ISO
2110

Information technology — Data communication — 25-pole DTE/DCE interface connector and contact number assignments

AMENDMENT 1: Interface connector and contact assignments for a DTE/DCE interface for data signalling rates above 20 000 bit/s

Figure B.1 — Active interconnect circuit

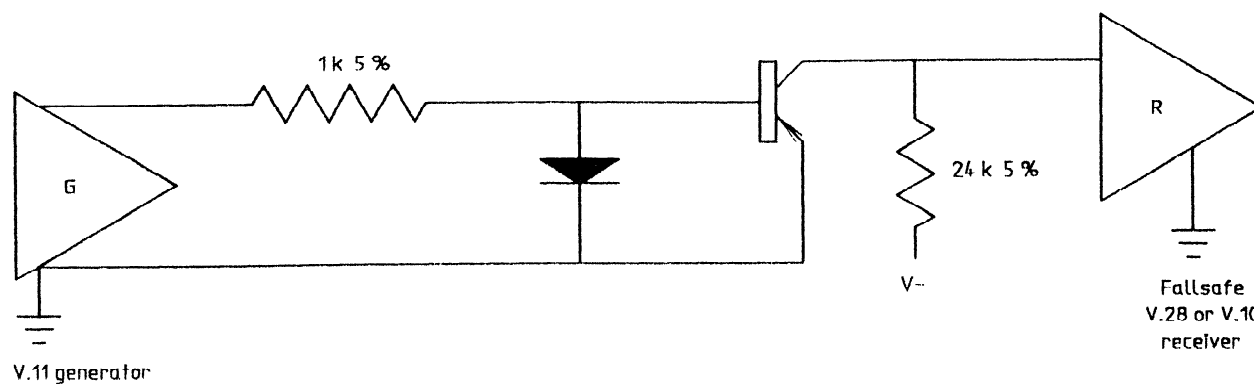
Table B.1 illustrates the contact assignments for ISO 4902 with a cross reference to the corresponding CCITT Recommendation V.24 circuit assignments for the above column. It should be noted that Circuits 107 and 108 have an "A" and "B" assignment (use CCITT V.11 electrical characteristics) in ISO 4902, whereas they have a single assignment (use CCITT V.10 electrical characteristics) in ISO 2110, column M. Therefore, they require the use of an active interconnect circuit, similar to that shown in figure B.1, on circuits where a V.11 driver is being used with a V.10 receiver.

Although CCITT Recommendation V.35 is no longer recommended for use by CCITT, interoperation between ISO 2110, column M, and this equipment is possible. The use of an active circuit (similar to that shown in figure B.1) is recommended for the case where a V.11 driver is connected to a V.35 unbalanced (V.28) receiver.
